Attachment 1 Responses-to-Comments Table

Application for Amendment of Plan Under Section 12A of the Town Planning Ordinance (Cap.131), to Rezone the Application Site from “Open Storage”, “Agriculture” Zones and an area shown as ‘Road’ to “Other Specified Uses” annotated “Mixed Use” Zone, for Proposed Mixed Use Development at Lots 796 and 1008 RP in D.D. 77 and Adjoining Government Land in Ping Che, Ta Kwu Ling, New Territories Response to Departmental Comment

Comments from Related Departments	Page No.
1. Drainage Services Department, dated 22 May 2024	2
2. Environmental Protection Department, dated 20 May 2024	2

BASEMENT LEVEL 1 PLAN SK-10
PROPOSED DEVELOPMENT AT PING CHE DD77, N.T.

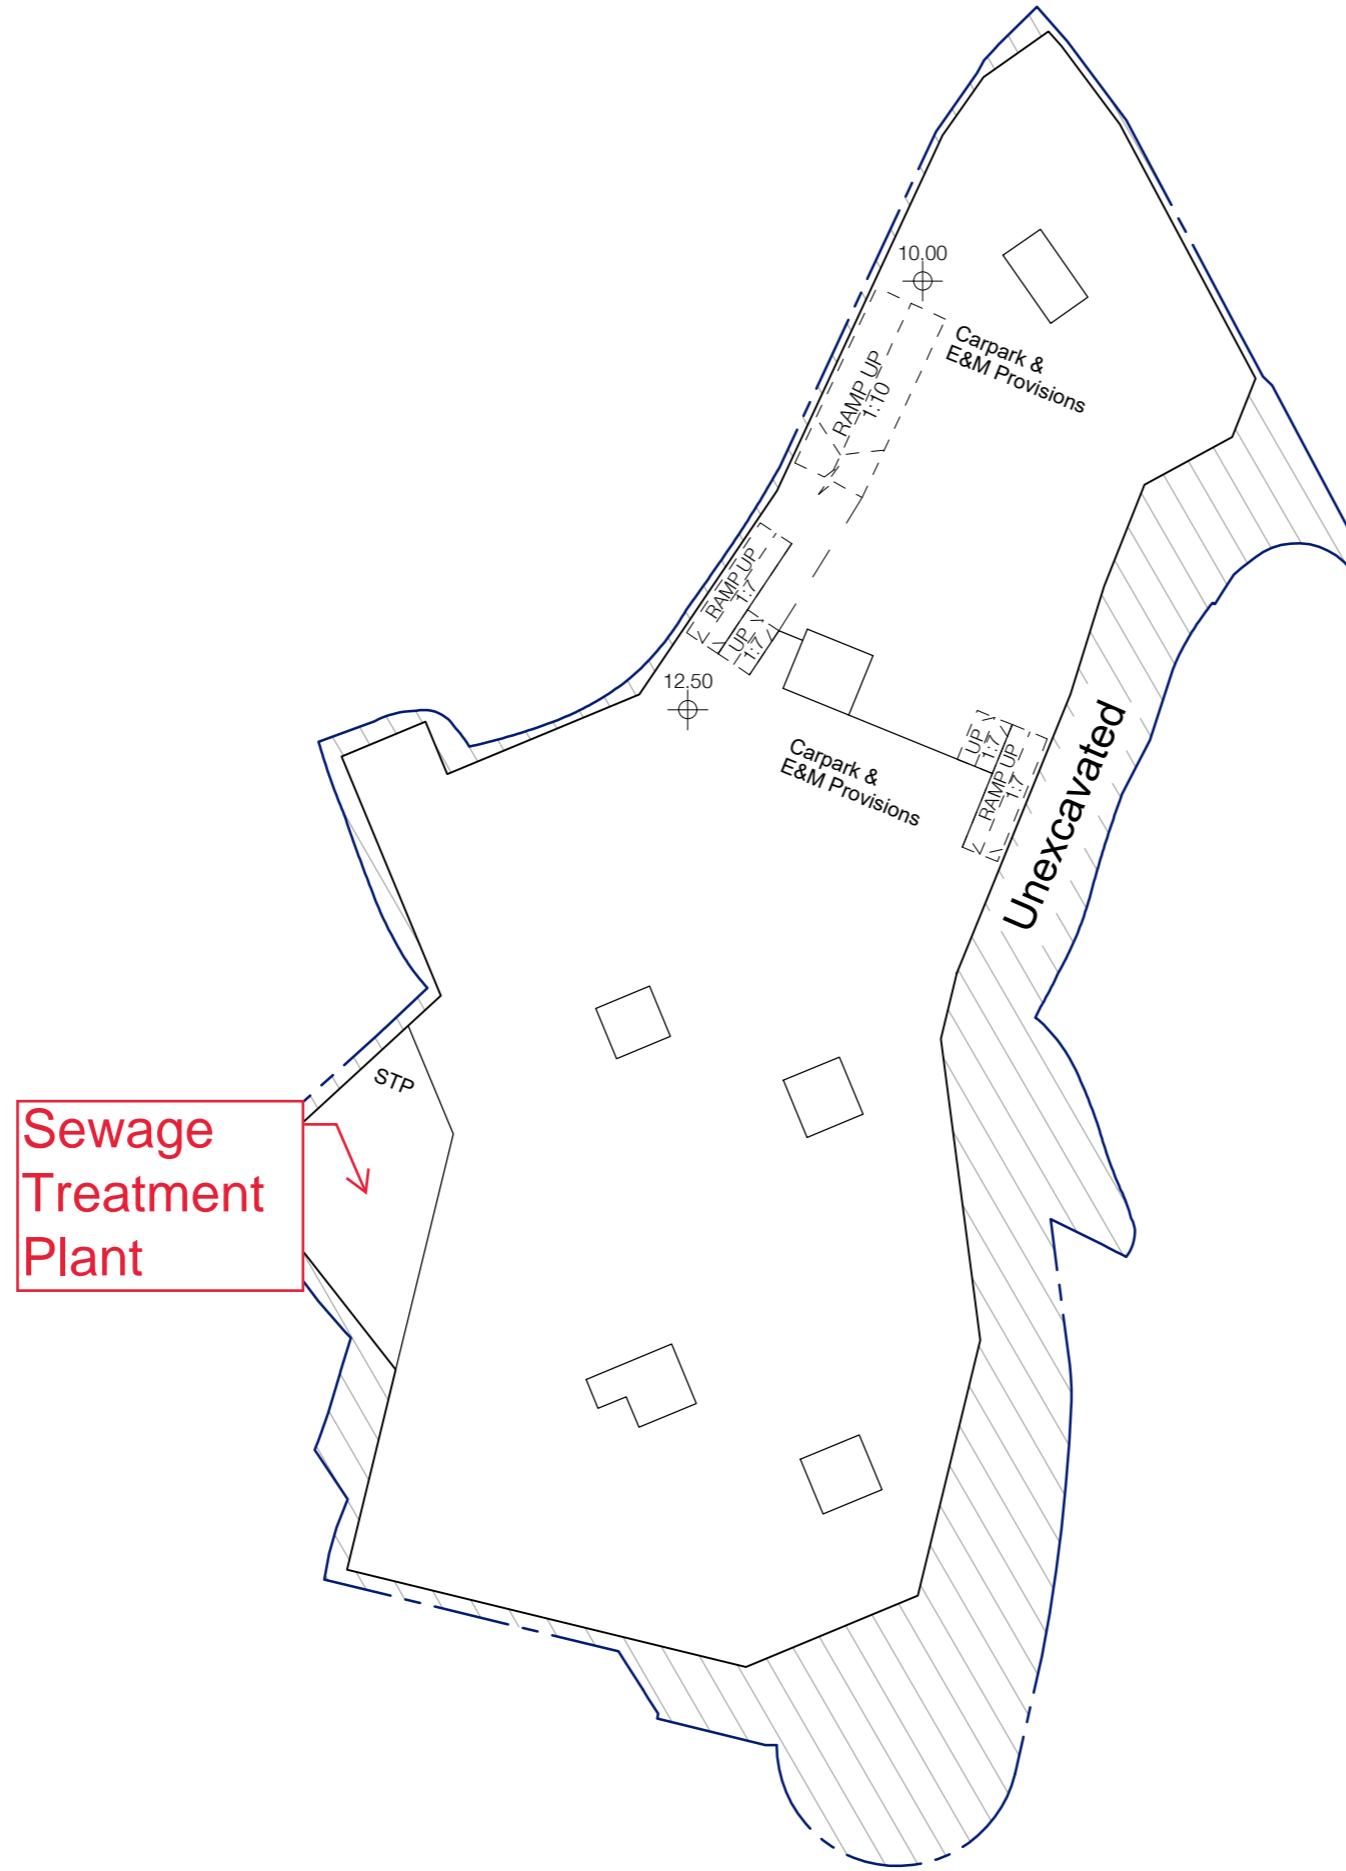
<p>9 . Section 5.7.2</p> <p>No sewage treatment plant could be found in Appendix 3.1. Please check.</p>	<p>Noted. Please refer to the indication of Sewage Treatment Plant as shown in Drawing Basement Level 1 Plan SK-10 of Appendix 3.1 in Annex B.</p>
	<p><u>Noise Perspective</u></p> <p>10 . To ensure the noise mitigation measures proposed by the Applicant will be incorporated into the future development, and considering there is no mechanism to impose approval condition for S.12A rezoning applications, control should be in place under land mechanism by special conditions under the lease modification to require the developer to submit a Noise Impact Assessment and implement the design and mitigation measures recommended therein.</p>	<p>Noted.</p>
	<p>11 . Section 6.3.18</p> <p>It shall read “...the provision of acoustic window/acoustic door (Baffle type) to let them be well aware of the intended purpose, appropriate use and correct setting.”</p>	<p>Noted. Section 6.3.18 of Annex B has been revised.</p>
